Access Compliance Report Public Rights-of-Way (Curb Ramps)

Main Street: MARTHA_ANN_DR Cross Street: WOODSTOCK_RD Location: NE

ADA ID: RPAT211206130134 Ramp Type: Type 1 - Perpendicular Diagonal Initial Pass/Fail: Pass Overall Compliance: No Severity Score: 16

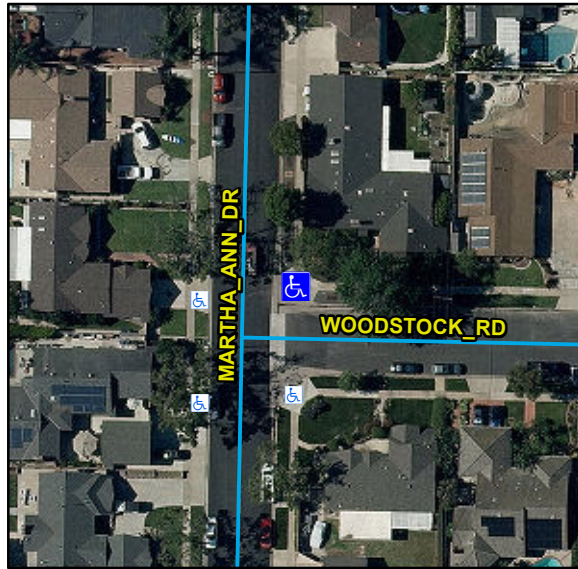
R304.2.2, R204.3, R304.2.1, R304.2.2-Perp, R304.3.2-Para, R305, STD 1115

Remove & Replace Curb Ramp With Two New Directional Ramps or Equivalent.
